# QUIKTRIP 4283

## SITE PLAN

1st Review  
Aurora Water  
Jenny Wynn  
jwynn@auroragov.org

QUIKTRIP 4283  
E-470 & EAST 64TH AVENUE  
SITE PLAN  
COVERSHEET

**QUIKTRIP 4283**  
 E-470 & EAST 64TH AVENUE  
 SITE PLAN  
 LANDSCAPE PLAN

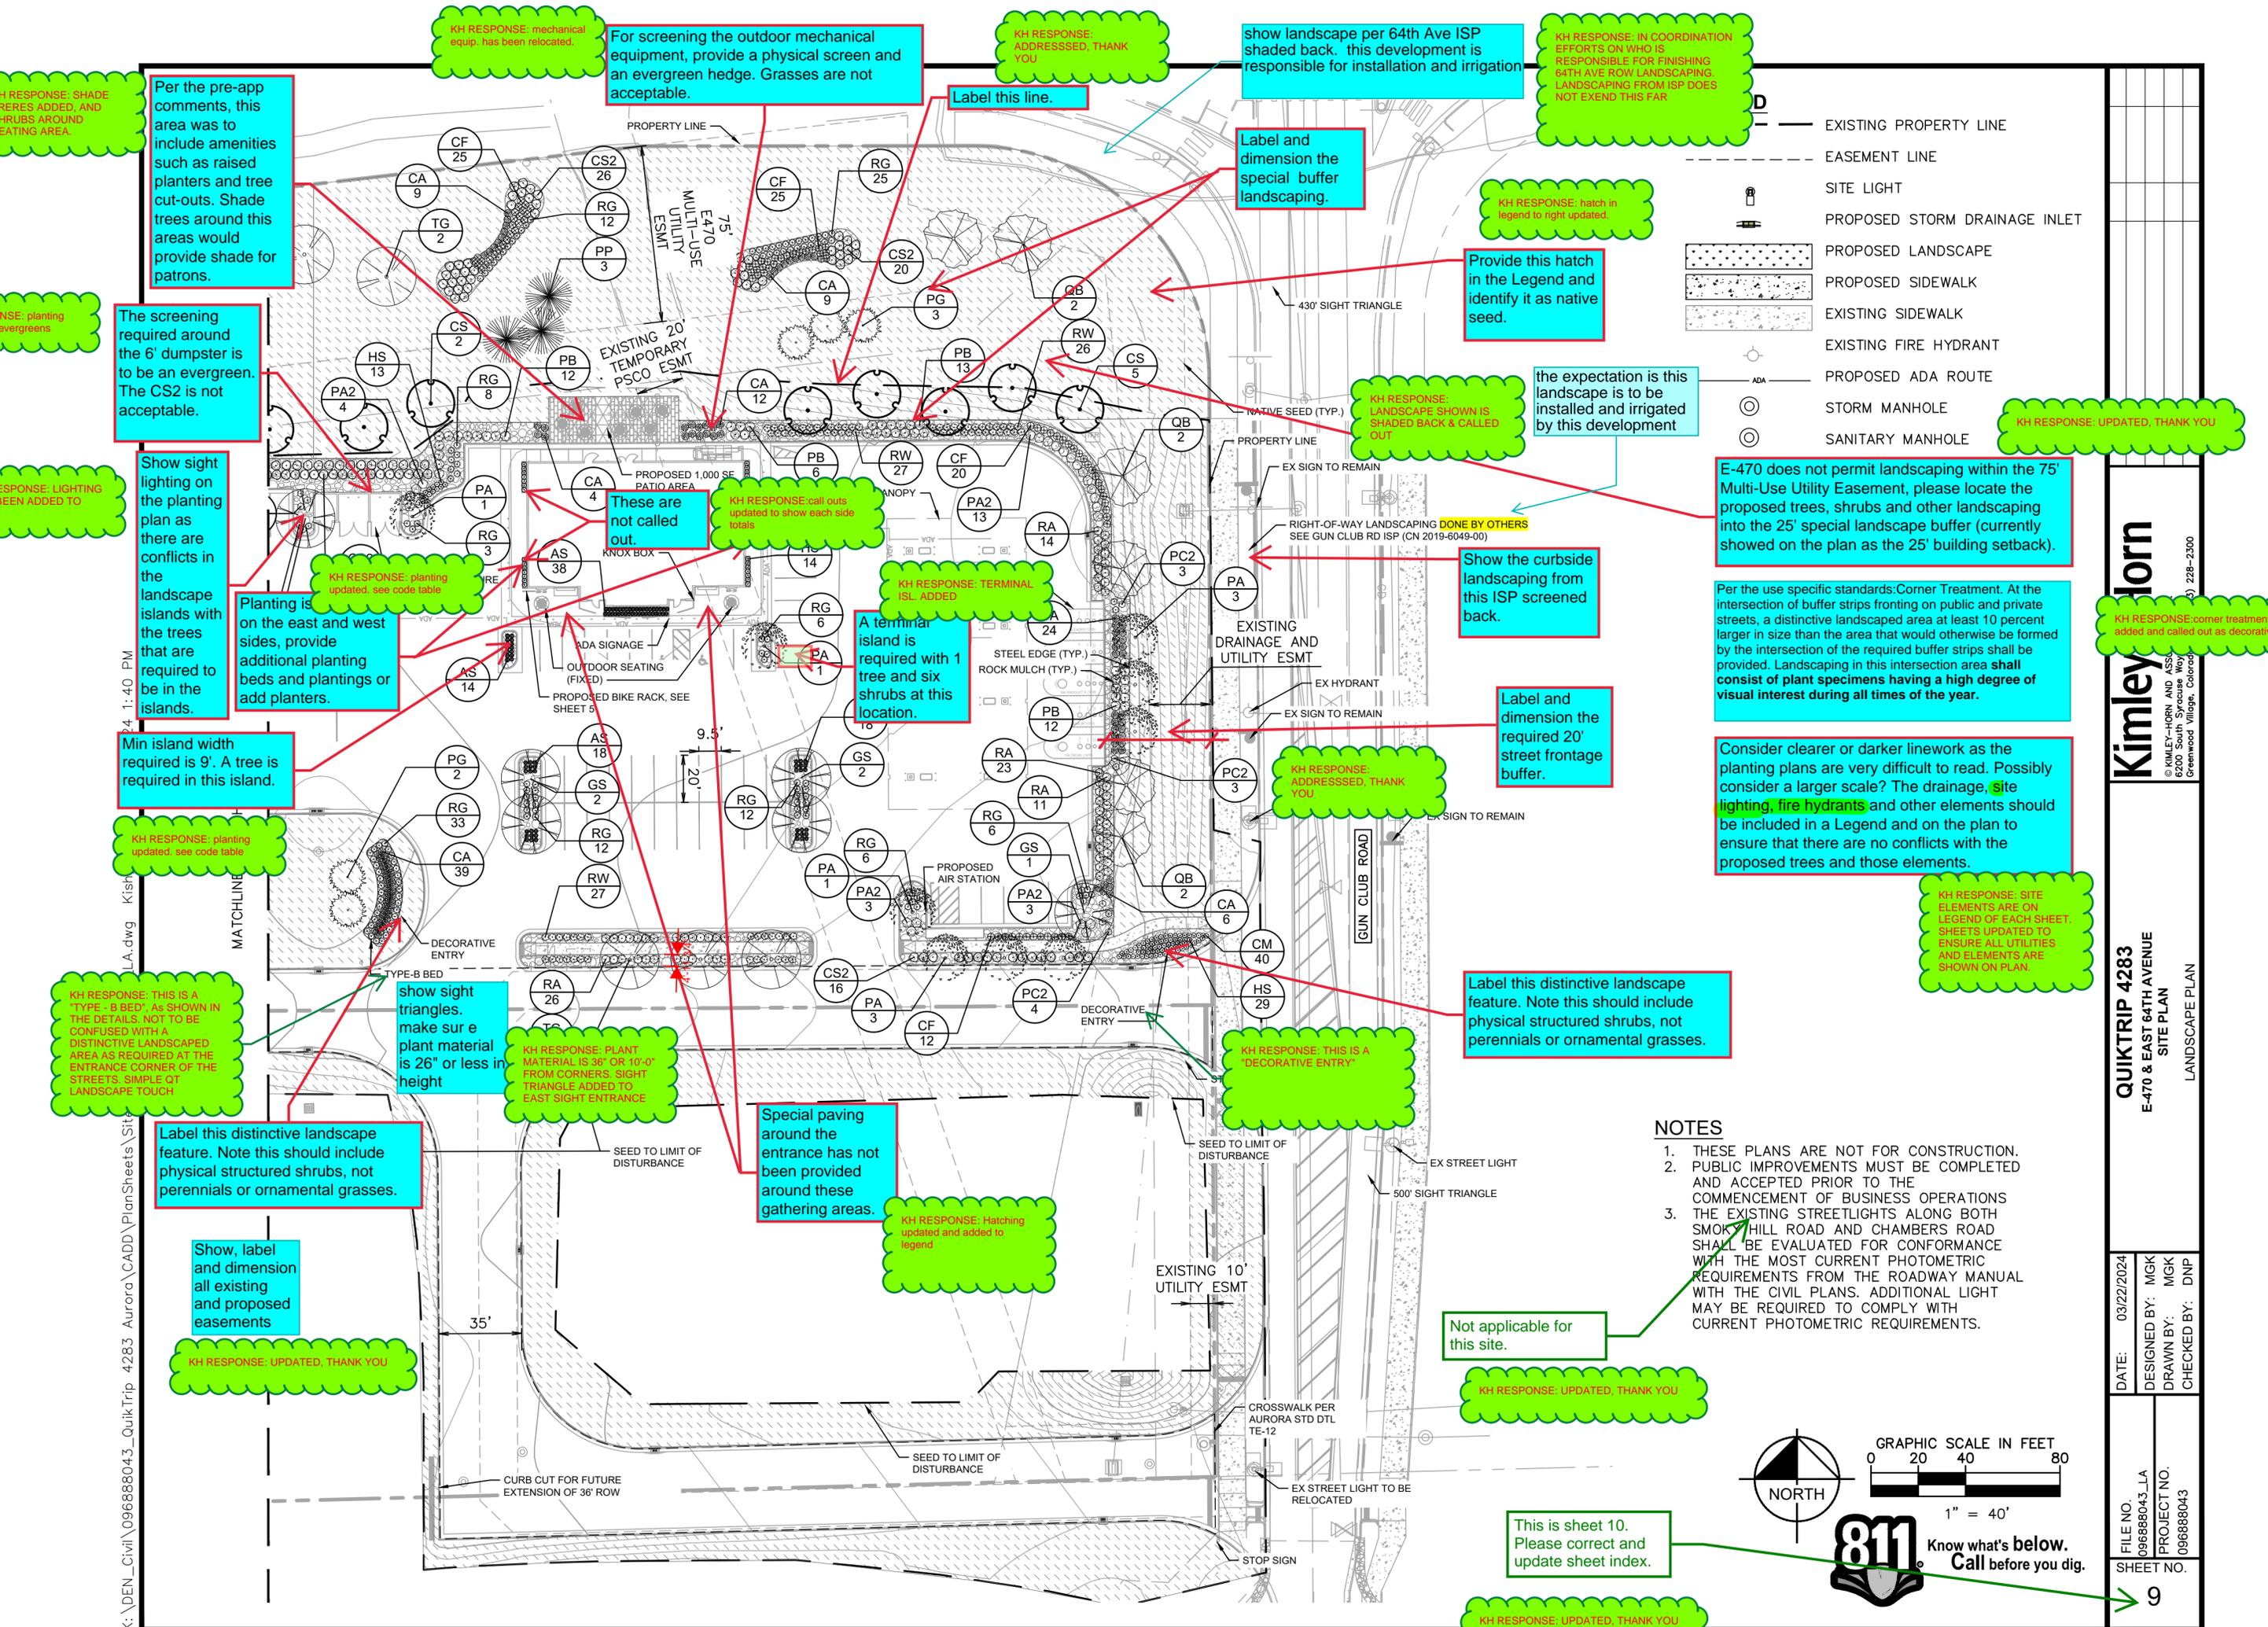
Typically E-470 does not permit landscaping within the 75' Multi-Use Utility Easement. please locate the proposed trees, shrubs and other landscaping into the 25' special landscape buffer (currently showed on the plan as the 25' building setback).

At least 50% of required trees along this special landscape buffer shall be evergreen species & shrubs may consist of tall deciduous & evergreen species planted a minimum of 5 feet on center. The RW, HS and CM do not meet this requirement. There are also no 50% evergreen trees.

Show sight lighting on the planting plan as there are conflicts in the landscape islands with the trees that are required to be in the islands.

Show, label and dimension all existing and proposed easements

For screening the outdoor mechanical equipment, provide a physical screen and an evergreen hedge. Grasses are not acceptable.

show landscape per 64th Ave ISP shaded back. this development is responsible for installation and irrigation

Provide this hatch in the Legend and identify it as native seed.

E-470 does not permit landscaping within the 75' Multi-Use Utility Easement, please locate the proposed trees, shrubs and other landscaping into the 25' special landscape buffer (currently showed on the plan as the 25' building setback).

Per the use specific standards: Corner Treatment. At the intersection of buffer strips fronting on public and private streets, a distinctive landscaped area at least 10 percent larger in size than the area that would otherwise be formed by the intersection of the required buffer strips shall be provided. Landscaping in this intersection area shall consist of plant specimens having a high degree of visual interest during all times of the year.

Consider clearer or darker linework as the planting plans are very difficult to read. Possibly consider a larger scale? The drainage, site lighting, fire hydrants and other elements should be included in a Legend and on the plan to ensure that there are no conflicts with the proposed trees and those elements.

Special paving around the entrance has not been provided around these gathering areas.

This is sheet 10. Please correct and update sheet index.

**KH RESPONSE: UPDATED, THANK YOU**

**KH RESPONSE: 24 OF THE REQ. 42 SPEC. BUFFER TREES WERE EVERGREEN. (57%) PLAN HAS BEEN UPDATED TO SHOW 50% OVERALL EVERGREEN TREES PROV. LANDSCAPE CODE TABLE HAS BEEN UPDATED TO BETTER REFLECT INTENT AND CODE REQ.**

KH RESPONSE: planting updated, see code table

KH RESPONSE: UPDATED, THANK YOU

KH RESPONSE: mechanical equip. has been relocated.

KH RESPONSE: IN COORDINATION EFFORTS ON WHO IS RESPONSIBLE FOR FINISHING 64TH AVE ROW LANDSCAPING. LANDSCAPING FROM ISP DOES NOT EXTEND THIS FAR

KH RESPONSE: hatch in legend to right updated.

KH RESPONSE: SITE ELEMENTS ARE ON LEGEND OF EACH SHEET. SHEETS UPDATED TO ENSURE ALL UTILITIES AND ELEMENTS ARE SHOWN ON PLAN.

KH RESPONSE: Hatching updated and added to legend

KH RESPONSE: UPDATED, THANK YOU

**QUIKTRIP 4283**  
E-470 & EAST 64TH AVENUE  
SITE PLAN  
LANDSCAPE NOTES

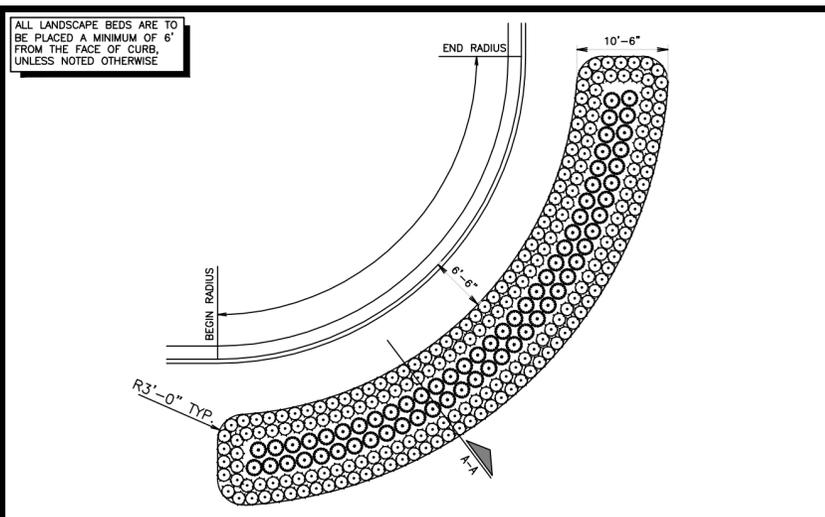
Remove and organize plant material by type in the table. Show the trees first in the list.

Show a column for the plant ID and then the quantity in the next column

Show the shrubs, ornamental grasses and perennials in separate categories in the Plant List.

This exceeds the code requirement of a maximum of 30%. Reduce the ornamental grasses on the planting plans to below 30%.

Provide the water usage table for this project to describe the high, medium and low water usage with the square footage of the area and percentage of the overall site.

These are the tree sizes at maturity, please remove them from the plant list as the trees are not being specified that size.

KH RESPONSE UPDATED, THANK YOU

KH RESPONSE UPDATED, THANK YOU

KH RESPONSE UPDATED, THANK YOU

KH RESPONSE: WATER USAGE TABLE ADDED

INVERTED\_U-BIKE

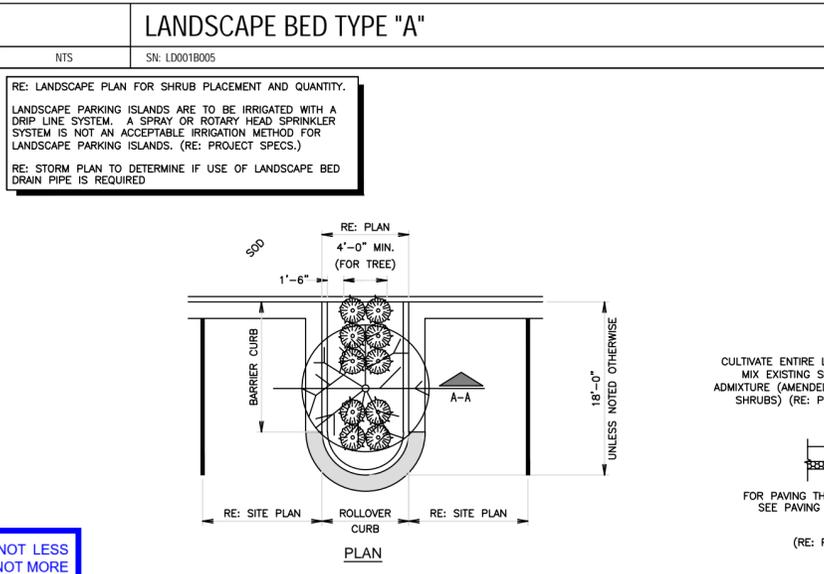
Bike rack detail on this sheet to be utilized.

**QUIKTRIP 4283**  
E-470 & EAST 64TH AVENUE  
SITE PLAN  
PHOTOMETRIC PLAN

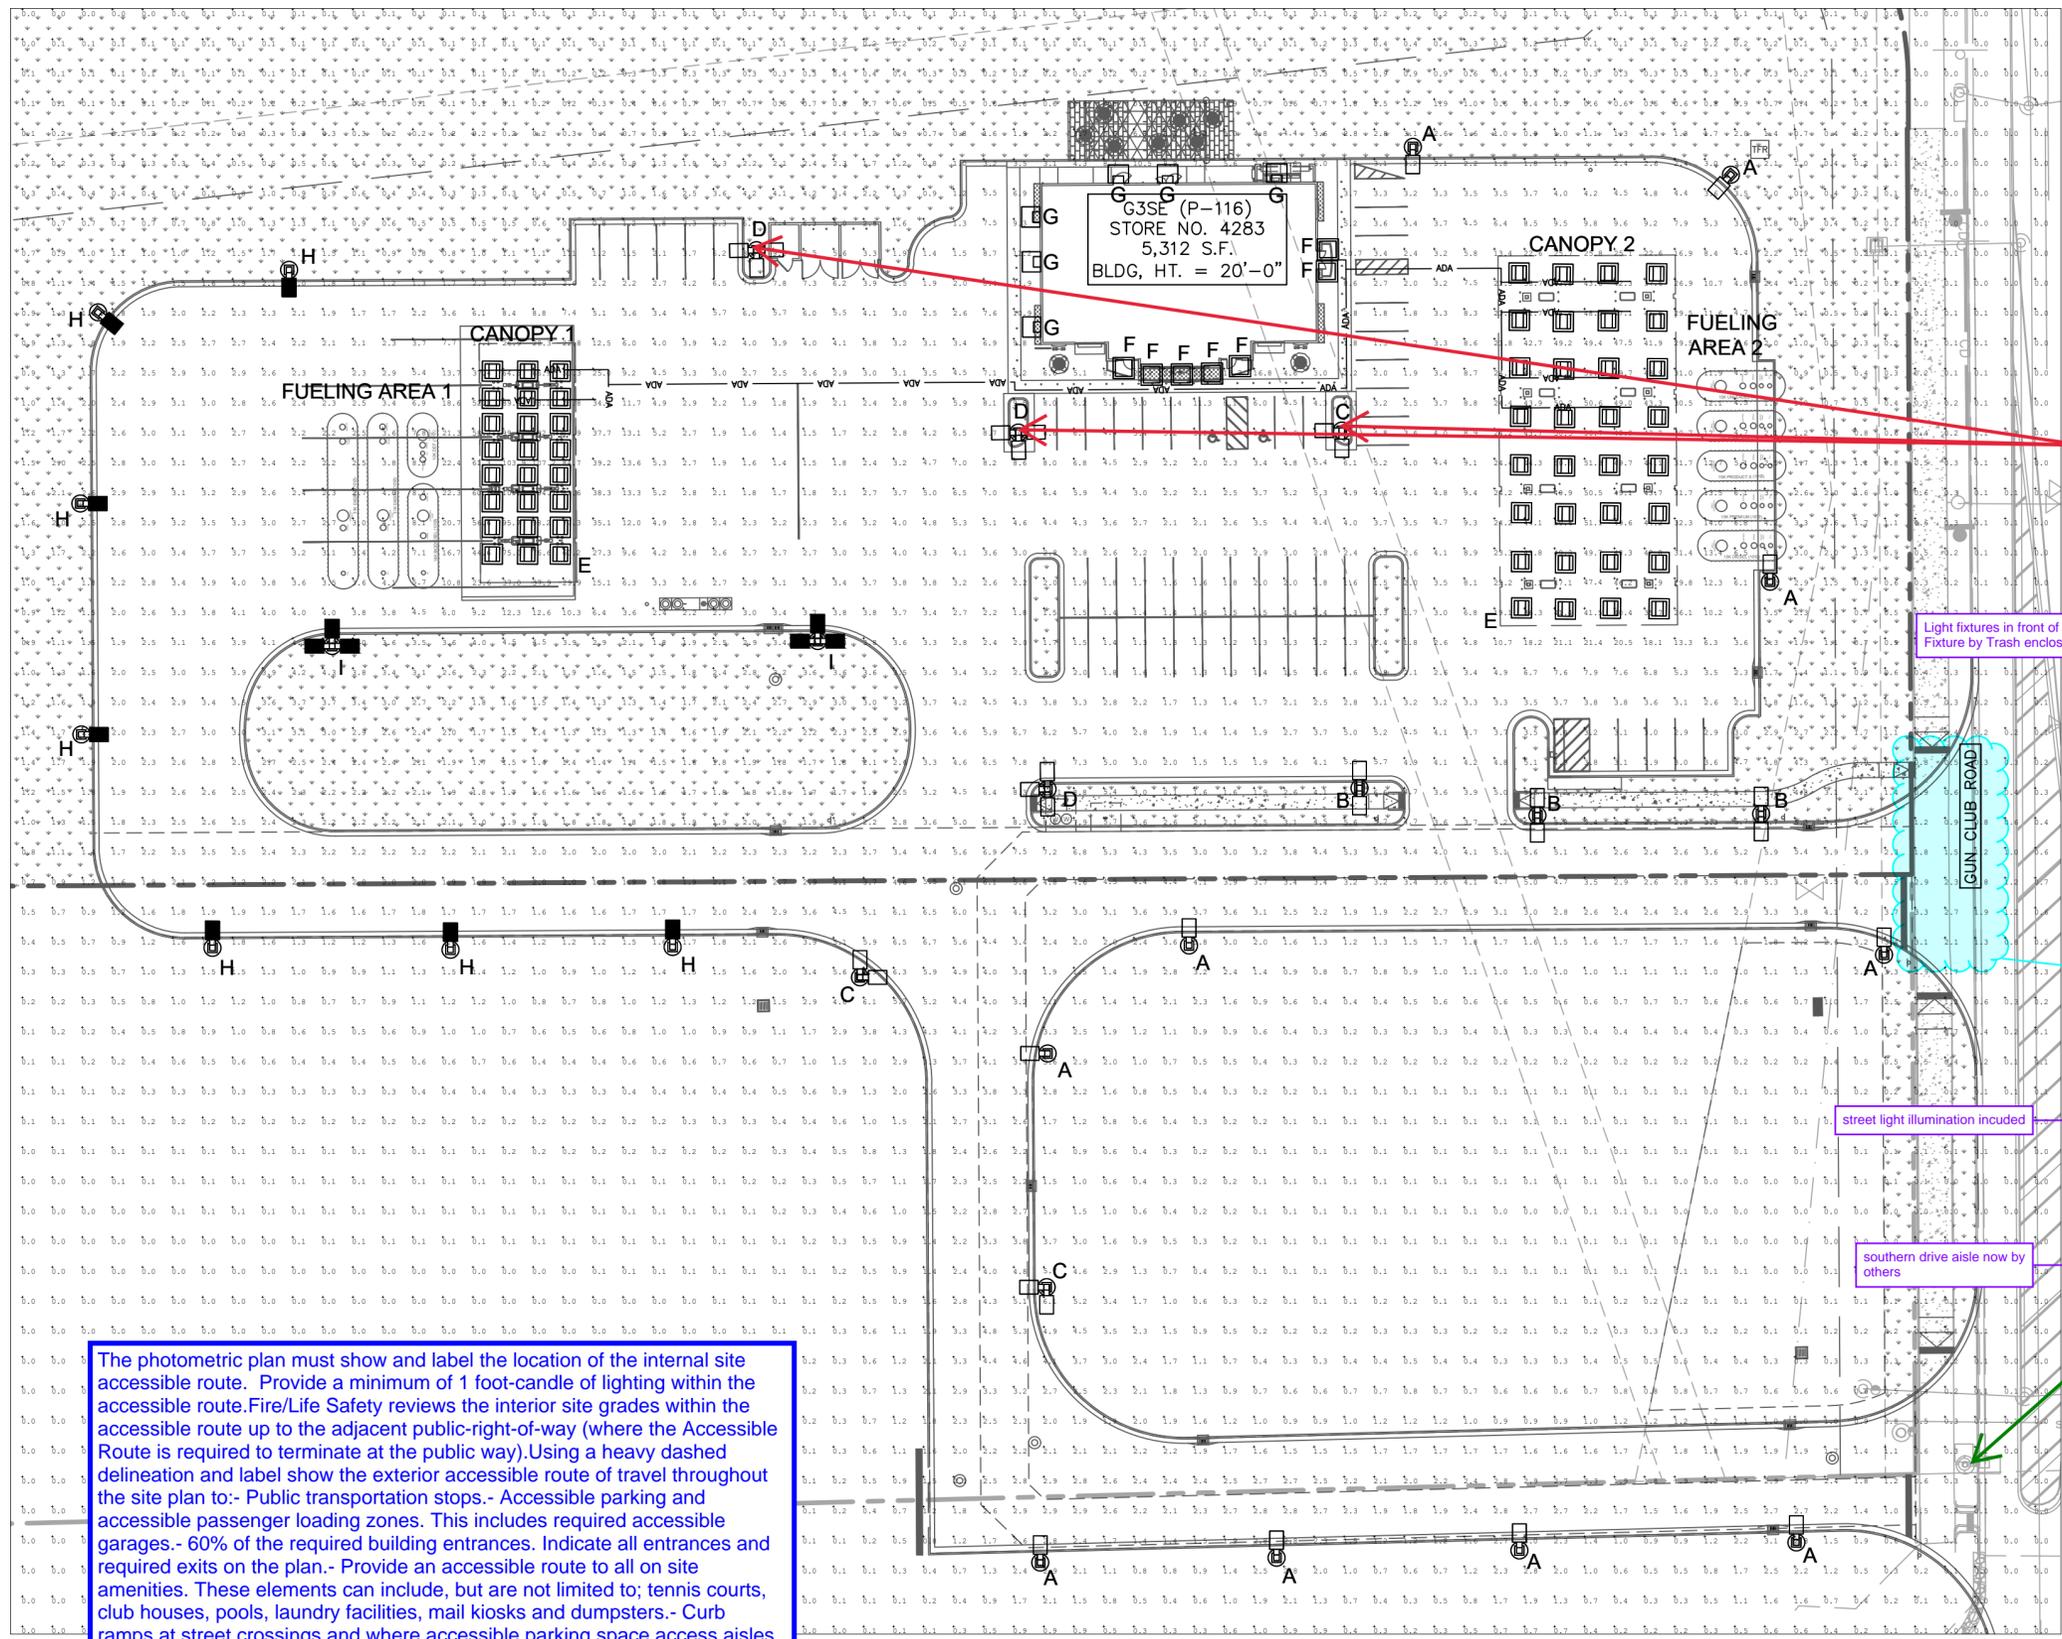
Show sight lighting on the planting plan as there are conflicts in the landscape islands with the trees that are required to be in the islands. Adjust light poles out of the landscape islands.

add light fixture symbols

Call the existing street light to be removed, and show location of the proposed street light.

The photometric plan must show and label the location of the internal site accessible route. Provide a minimum of 1 foot-candle of lighting within the accessible route. Fire/Life Safety reviews the interior site grades within the accessible route up to the adjacent public-right-of-way (where the Accessible Route is required to terminate at the public way). Using a heavy dashed delineation and label show the exterior accessible route of travel throughout the site plan to:- Public transportation stops.- Accessible parking and accessible passenger loading zones. This includes required accessible garages.- 60% of the required building entrances. Indicate all entrances and required exits on the plan.- Provide an accessible route to all on site amenities. These elements can include, but are not limited to; tennis courts, club houses, pools, laundry facilities, mail kiosks and dumpsters.- Curb ramps at street crossings and where accessible parking space access aisles connect to adjacent sidewalks.- Provide marked crosswalks in all areas where the accessible route crosses a drive aisle.- Accessible routes must be shown passing through gated entry(s) served. - Show and label the location of accessible units required by IBC Chapter 11 and the revised 2003 HB-1221 to be part of the exterior accessible route.

Light fixtures added to legend

Minimum of 1.8 fc added to calculation summary
